CHANGE ORDER NUMBER: 2

Project: Round 1809-259

Roadway: Lakeline Right Turn Lane

Change Order No. 2

2851 1/2 S. LAKELINE BLVD.
LAKELINE TURN LANE
PROPOSED SIGNAL LAYOUT -
LAKELINE/ HEB DRIVEWAY

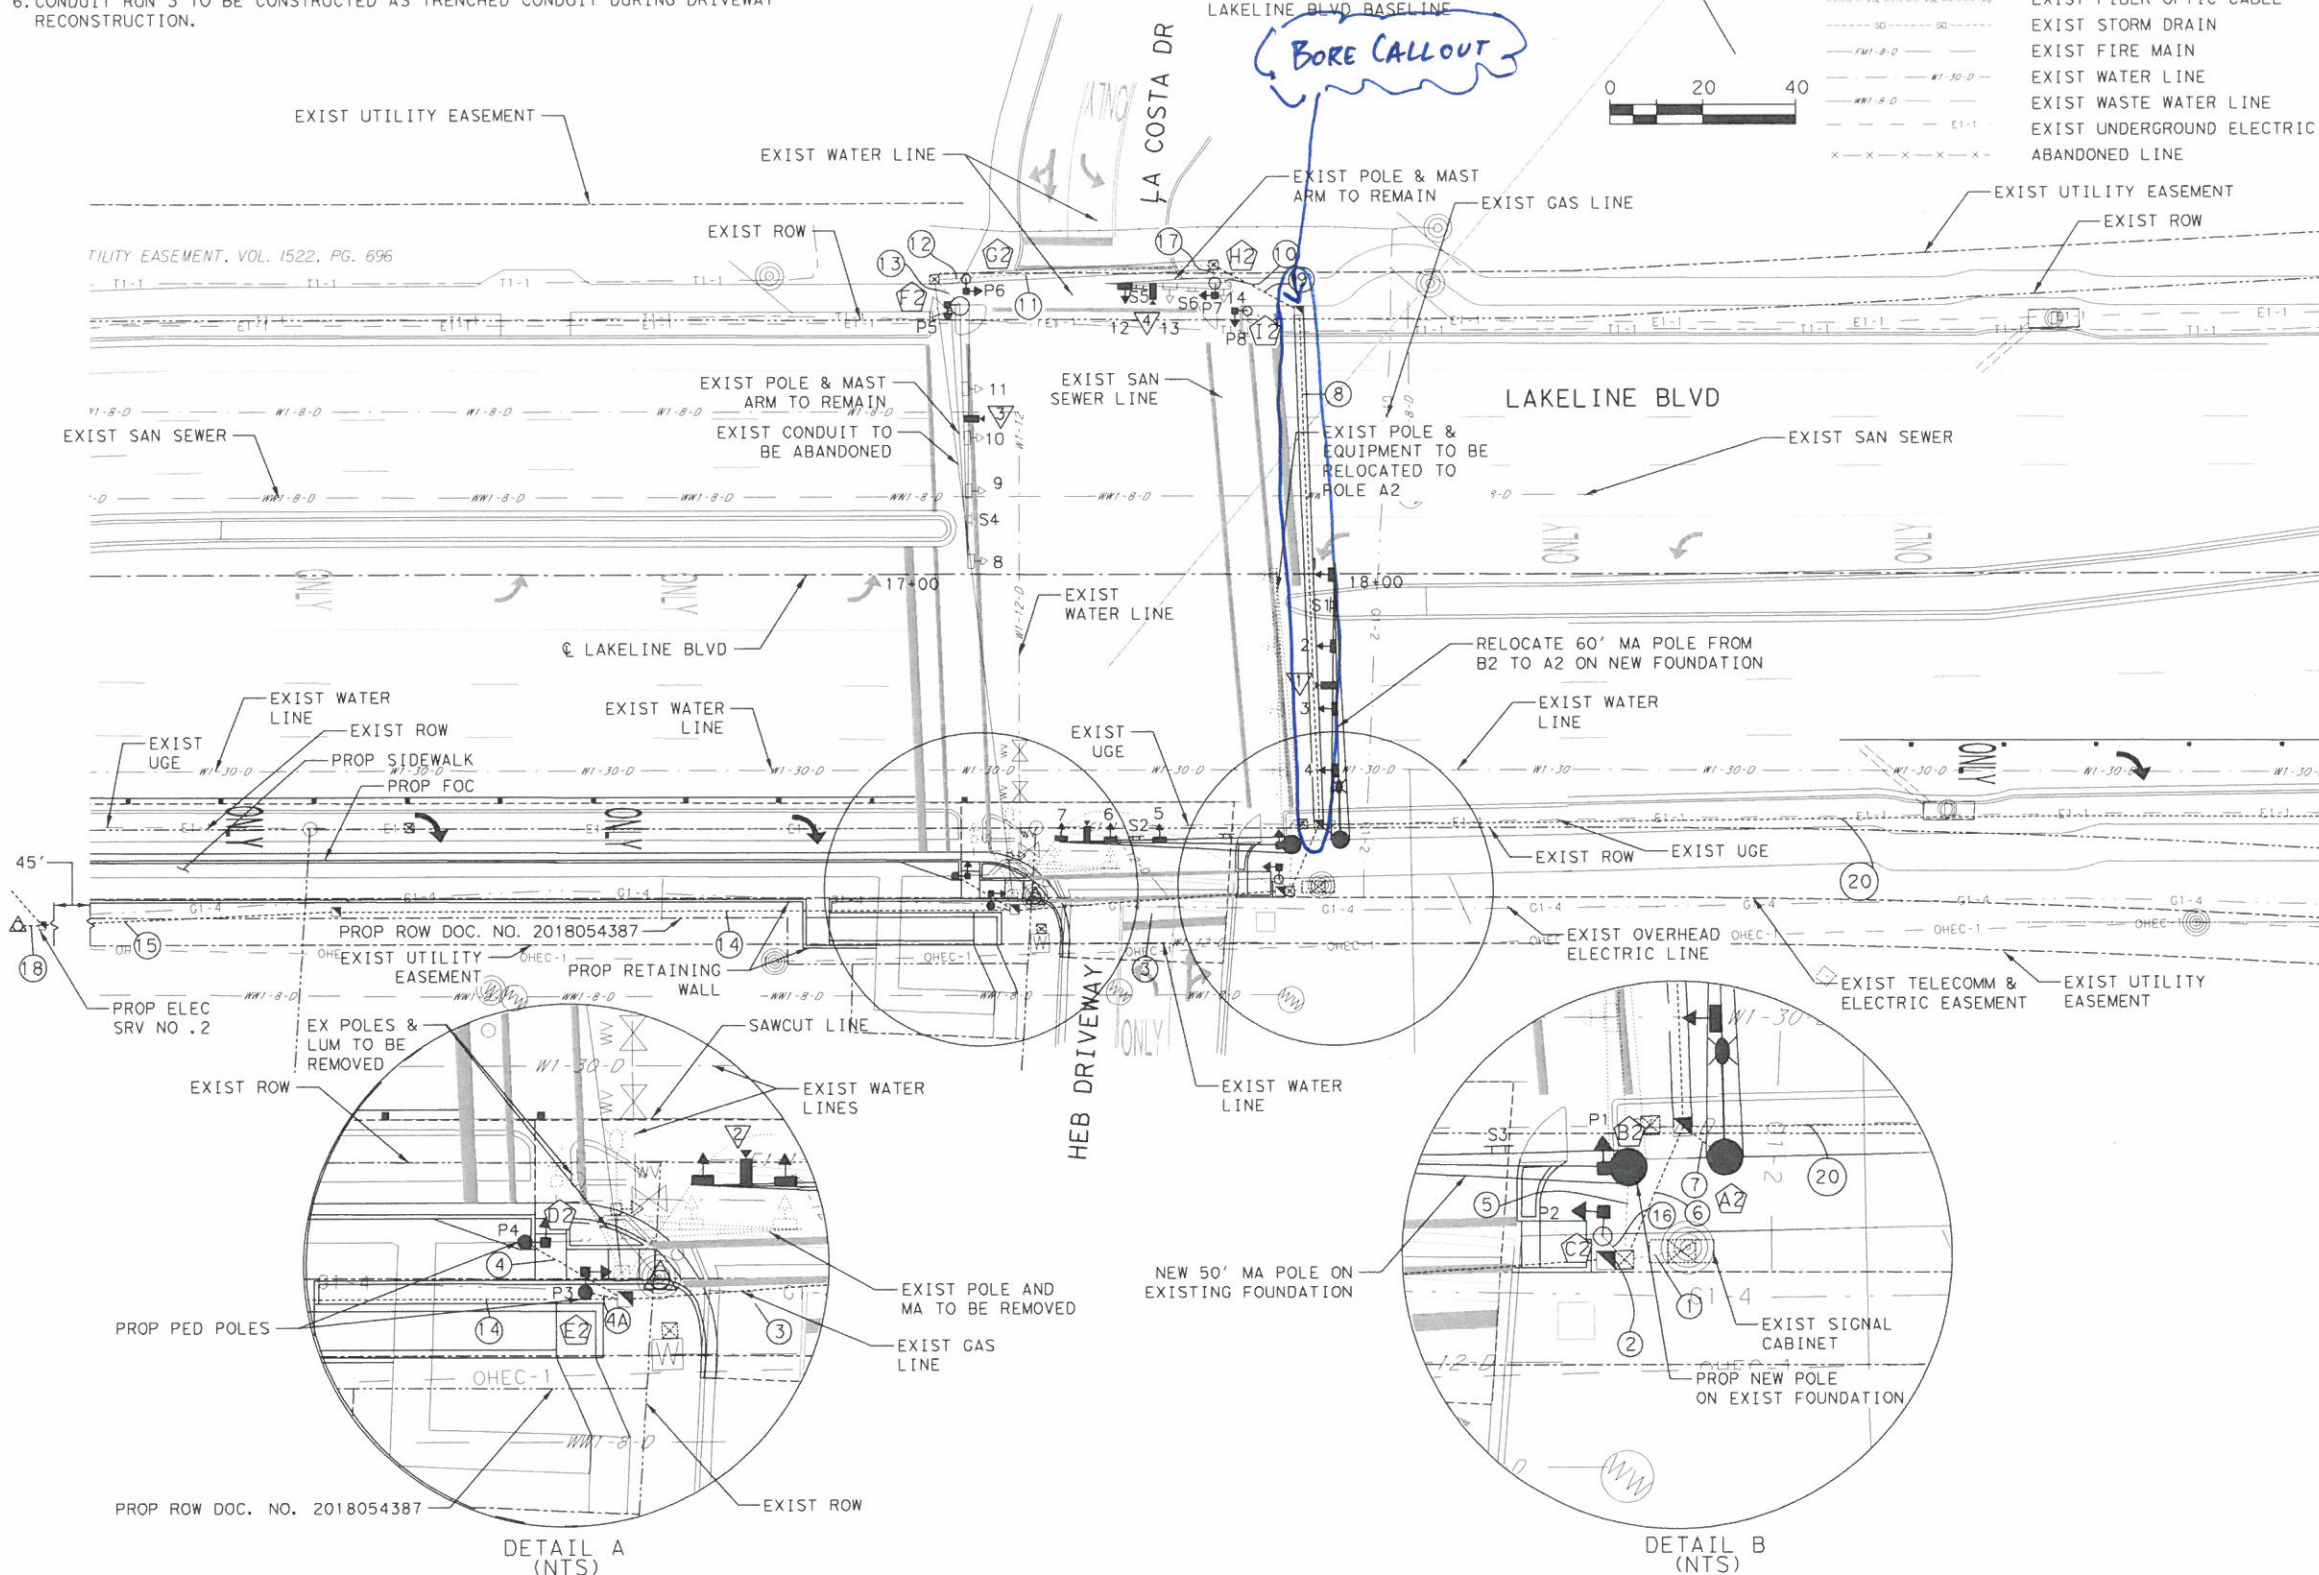
This Change Order also adds pay items for the 2-inch and 3-inch conduit bores called for in the plan items for the proposed signal at the HEB driveway. The plans called for new conduit to be bored across Lakeline Boulevard, but the pay items for this work were not included in the bid tab.

- 1) ABOVE WORK IS SHOWN IN CIVIL SHEETS-Page 29- BUT NO CONTRACT PAY ITEM
- 2) BORE PROFILE IS NOT INCLUDED- IF REQUIRED, PAYMENT SHALL BE BY FORCE ACCOUNT

ITEM	DESCRIPTION	QTY	UNIT
835S-LT2	CONDT-PVC-SCH 80-2 INCH-BORE	140	LF
835S-LT3	CONDT-PVC-SCH 80-3 INCH-BORE	280	LF
999-WC03	ELEVATED CURB ON PROPOSED SIDEWALK	1174	SF

SIDEWALK CURB DETAIL

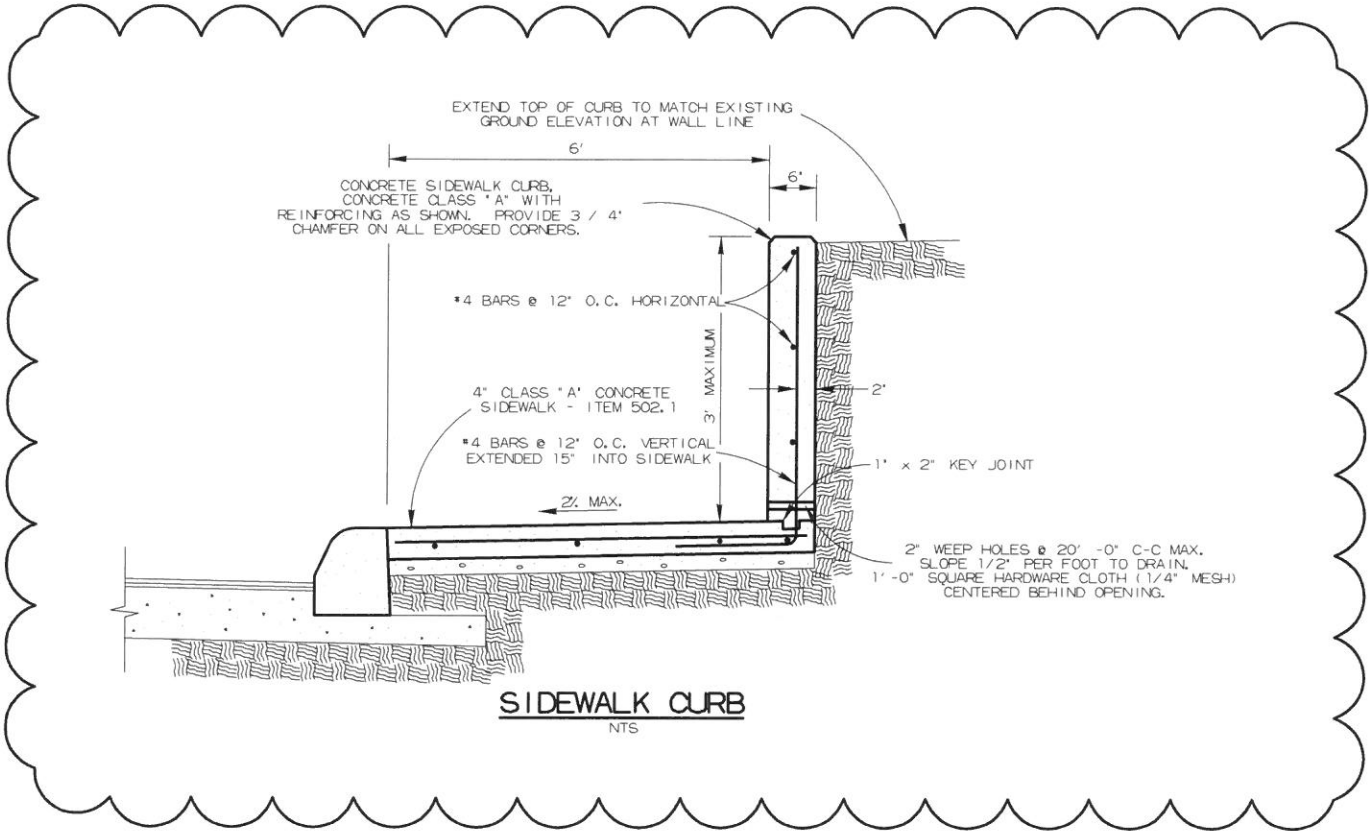
This Change Order replaces the proposed concrete block retaining wall with a concrete curb placed along the proposed sidewalk, due to the proximity of the sidewalk to the existing Austin Energy (A/E) poles. The actual location of the A/E poles put the poles too close to the proposed sidewalk and block wall. Per A/E, all construction should be a minimum of 2 feet from the poles. To provide this clearance, the wider block wall was replaced with a narrower concrete curb.

The estimate below is for 2.42ft of stand-up curb attached to the back of ±485ft of 6ft sidewalk for a total of ±1,174ft² of stand-up curb. The following estimate, and supporting documents, provide justification for a final cost of \$38.48/ft² of stand-up curb (to include the 5" of surface area covered by the adjacent sidewalk). An additional 11 days of contract time is requested as well. Final cost is inclusive of the items listed below; no other costs are included in this proposal. Final cost will be based on \$38.48/ft².
